November 25, 1987

AMENDMENT TO FACILITY OPERATING LICENSE

Amendment No. 54  
License No. DPR-22

SAFETY EVALUATION BY THE OFFICE OF NUCLEAR REACTOR REGULATION  
RELATED TO AMENDMENT NO. 54 TO FACILITY OPERATING LICENSE NO. DPR-22

Figure 3.5-1 Single Loop Operation Surveillance Power/Flow Curve

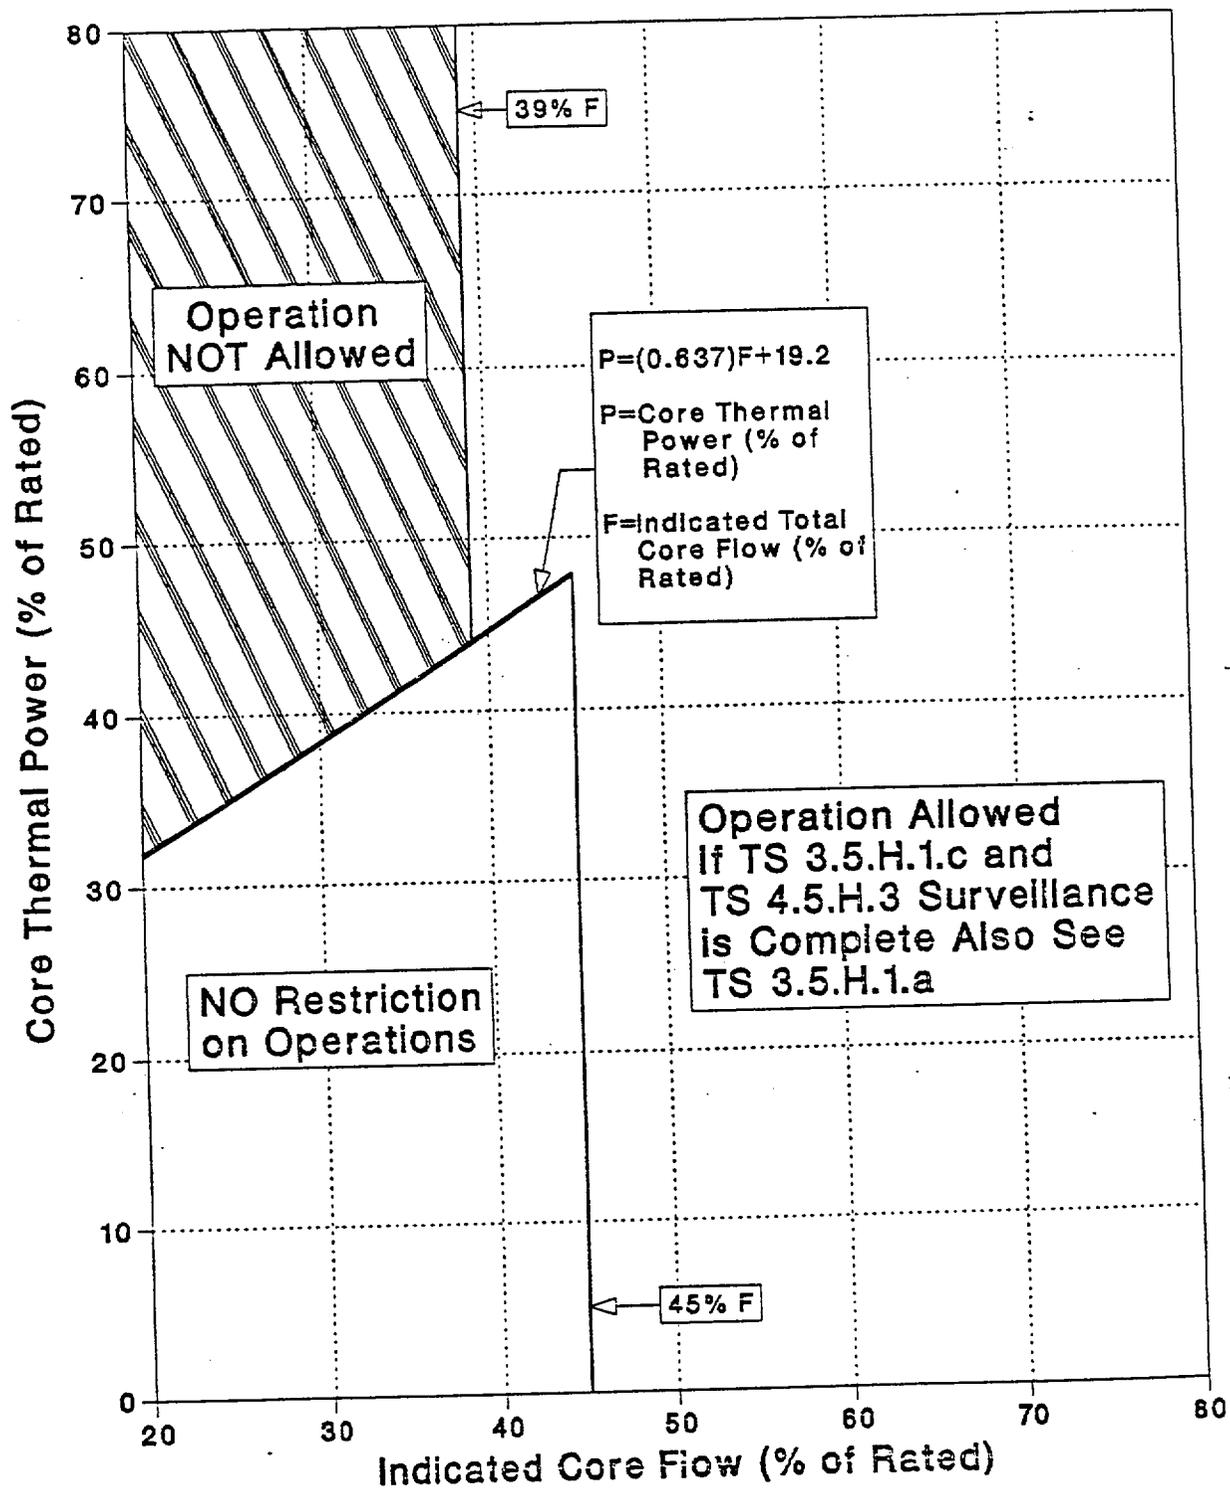
(d) Single loop operation surveillance power/flow curve.

Figure 3.5.1 has been redrawn to more clearly define for the operators the permissible operating regimes. This change is acceptable.

**FIGURE 3.11.2 MAPFAC<sub>F</sub> LIMITS**

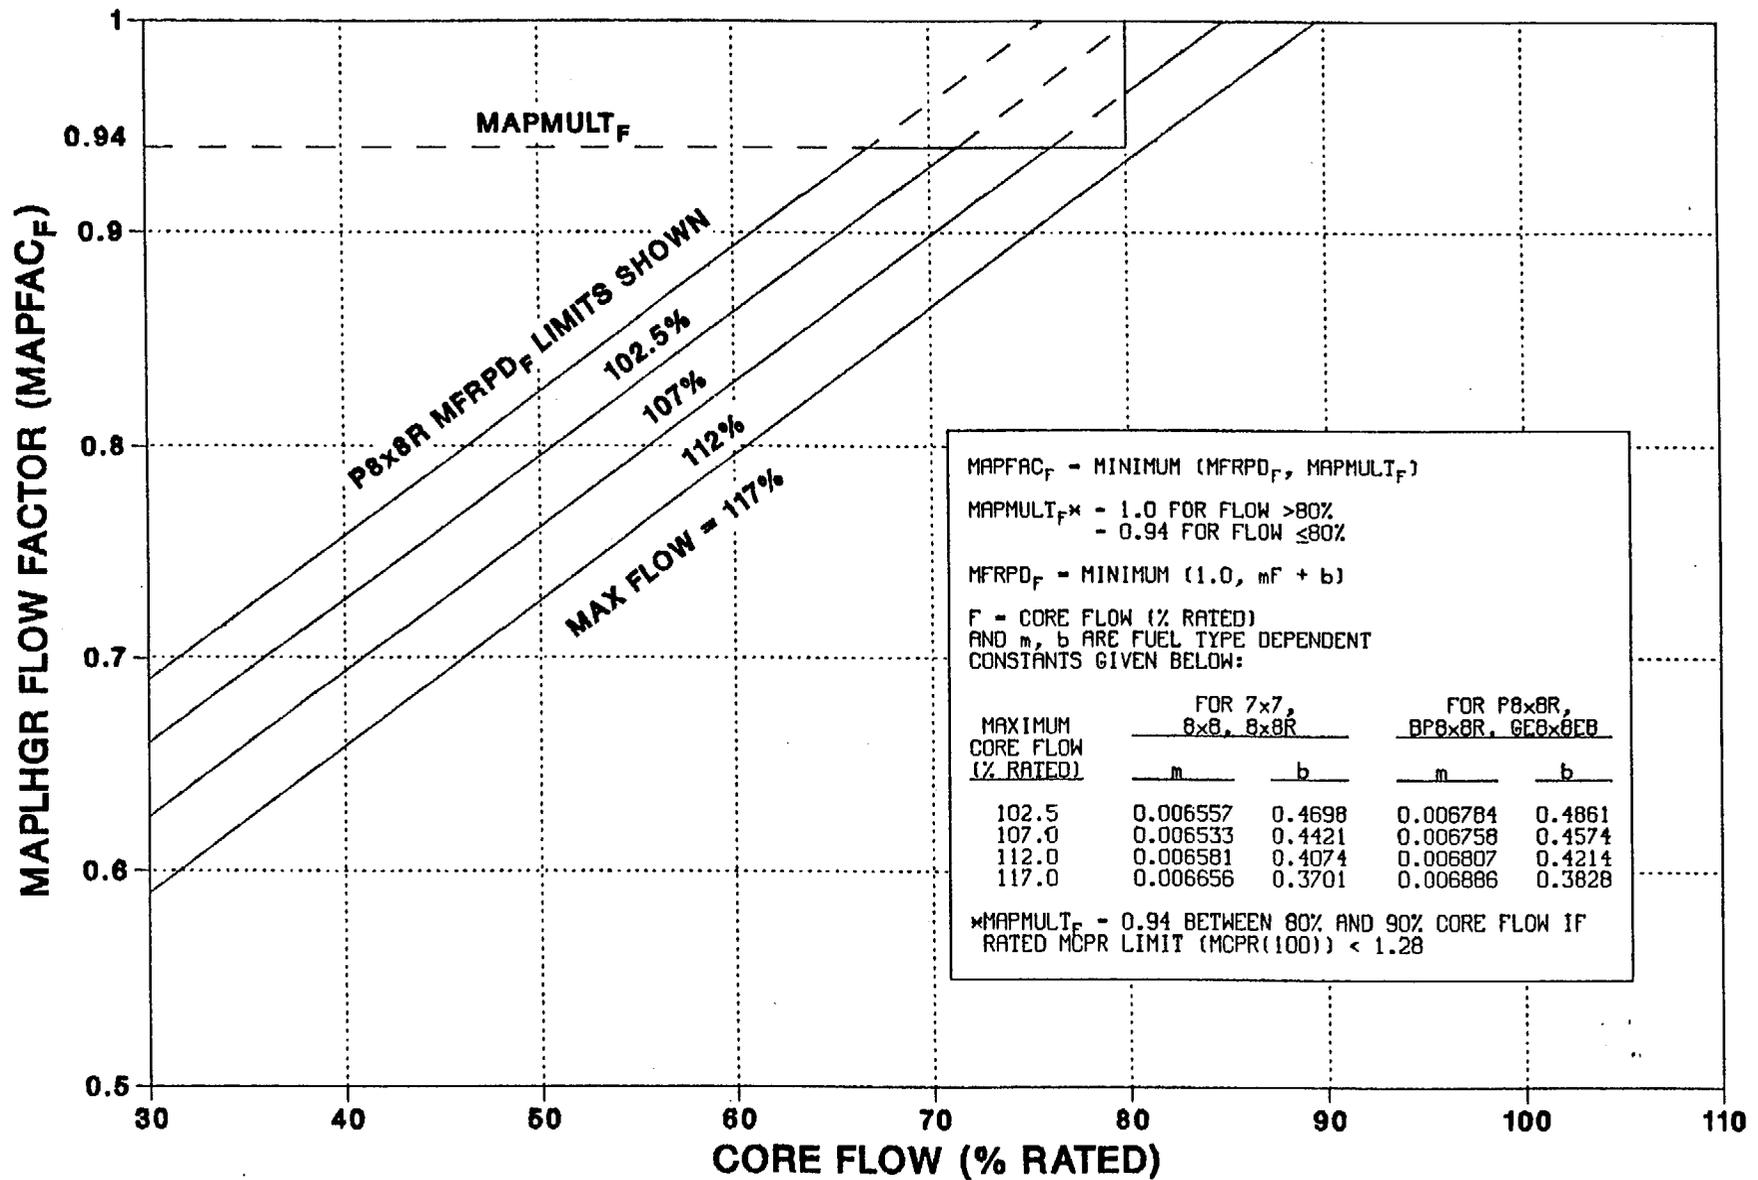
The flow dependent correction factor (Figure 3.11.2) applied to the rated condition's APLHGR limits assures that 1) the  $2200^\circ$  F PCT limit would not be exceeded during a LOCA initiated from less than rated core flow conditions and 2) the fuel thermal-mechanical design criteria would be met during abnormal transients initiated from less than rated core flow conditions. The power dependent correction factor (Figure 3.11.1) applied to the rated conditions APLHGR limits assures that the fuel thermal-mechanical design criteria would be met during abnormal transients initiated from all conditions (Reference 1).
